UNITED STATES PATENT AND TRADEMARK OFFICE

APPLICATION NO.	FILING DATE	FIRST NAMED INVENTOR	ATTORNEY DOCKET NO.	CONFIRMATION NO.
09/585,472	06/02/2000	Michiaki Sakamoto	157330/99	6609
21254	7590	02/10/2005		
MCGINN & GIBB, PLLC 8321 OLD COURTHOUSE ROAD SUITE 200 VIENNA, VA 22182-3817			EXAMINER RUDE, TIMOTHY L	
			ART UNIT 2883	PAPER NUMBER

Office Action Summary

FIG. 6(c)

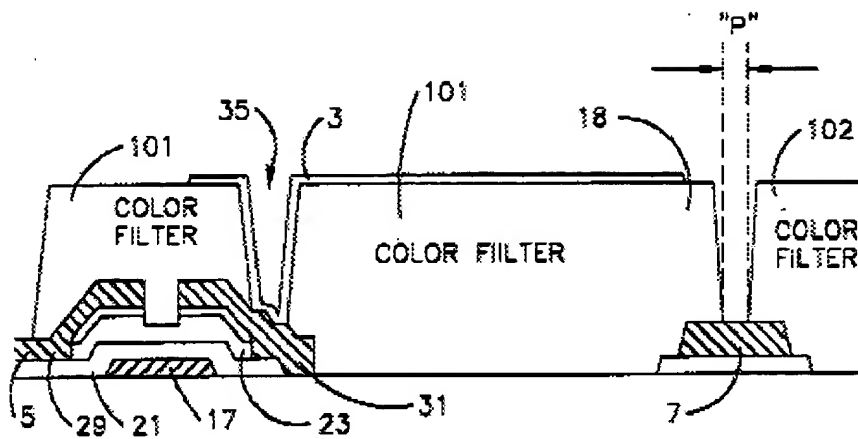
As to claim 1, Zhong discloses (entire patent, especially Figures 6(a)-6(c) and 11) an active matrix liquid crystal display device (col. 8, line 22 through col. 11, line 28), comprising: a first substrate, 19, and a second substrate, 51, at least one of said first substrate and said second substrate being transparent; a plurality of scanning lines, 7, formed on said first substrate; a plurality of signal lines, 5, formed on said first substrate crossing said scanning lines in a matrix manner a plurality of thin film transistors, each said thin film transistor respectively formed at an intersection of said scanning lines and said signal lines, each said thin film transistor comprising: a gate electrode, 17, formed on said first substrate; a gate insulation layer, 21, formed on said gate electrode; a semiconductor layer, 23, formed on said gate insulation layer; a drain electrode, 29, formed on a first portion of said semiconductor layer and a first portion of said gate insulation layer; and a source electrode, 31, formed on a second portion of said

semiconductor layer and a second portion of said gate insulation layer; at least one color filter, 101, formed on said first substrate; a plurality of pixel electrodes, 3, each respectively connected to one of said thin film transistors through a contact hole, 35, and each respectively formed on one of said at least one color filter; a counter electrode, 49, formed on said second substrate; and a liquid crystal layer, 45, between said first substrate and said second substrate, said liquid crystal layer being driven by electric fields between said pixel electrodes and said counter electrode to thereby make a display, wherein said color filter is formed directly on said first substrate (per Figure 6(c)) in most of a light transmission region within a pixel area surrounded by said scanning lines and said signal lines, providing an efficient high aperture display [Abstract, Applicant's a thickness of said color film forming said color filter being a preselected first thickness that provides a sufficient chromaticity for said color filter; please note that the display of Zhong has a preselected first thickness that does provide the color display of Zhong with efficient high aperture display performance, per Zhong], and said color film comprises a stack of layers that reduces a thickness of material of said color filter near said contact hole such that said second thickness is processed successfully to form a functional contact hole [Applicant's thickness chosen to permit a photo-crosslinkage to occur in an entire thickness of said second thickness of said color filter material during an exposure processing of said contact hole] (per Figure 6(c)).

As to claim 3, Zhong teaches the use of a color filter, 101, around said contact hole, 35, that is thinner than the color filter in said light transmission region (Figure 6c).

Zhong teaches the use of a color filter, 101, consisting of a photosensitive organic film (resist) with a color pigment or dye (col. 16, lines 43-46) that is substantially flat on the top surface (as illustrated in Figure 6c), therefore a difference in level generated on a surface of the organic film being not more than $0.3\ \mu\text{m}$ as a results effective variable for reducing line-pixel capacitances (Abstract) (MPEP 2144.05 II B).
